Access Compliance Report

Public Rights-of-Way

(Pedestrian Signals)

Intersection ID: N/A	Main Street:	Cross Street: N/A	Location: N/A
ADA ID: 90FCAF8012EC	Signal Type: One Push Button-Non APS	Overall Compliance: No	Severity Score: BTN 1: N/A BTN 2: N/A No BTN: N/A
Codes/Mitigation Info/Possible Solution		Field Measurements/Component Compliance

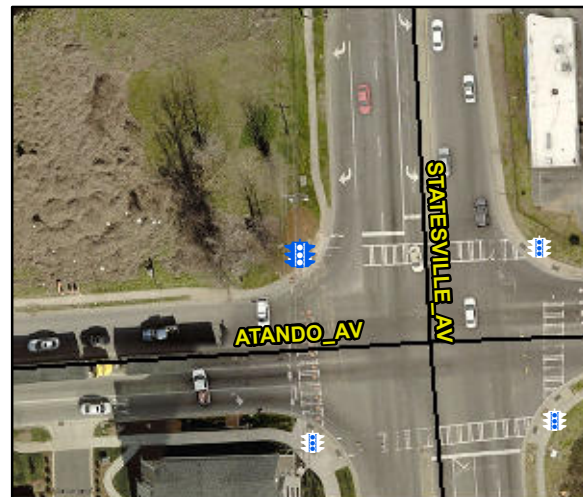
PROW/ADA: TMUTCD 4e.08, R404.3, R404.2, R404.7.3

Yes	B 1 Clear Xing Direction?	ClearlyMarked	N/A	B 2 Clear Xing Direction?	N/A
	B 1 Crossing Direction	To NE		B 2 Crossing Direction	N/A
Yes	B 1 DistanceTo XWalk (in)	0.0	N/A	B 2 DistanceTo XWalk (in)	N/A
No	B 1 DistanceTo Curb (in)	82.0	N/A	B 2 DistanceTo Curb (in)	N/A
Yes	B 1 Diameter (in)	2.0	N/A	B 2 Diameter (in)	N/A

Possible Solutions: Replace Signal Push Button With APS Button on New Post. Remove & Relocate Sign.
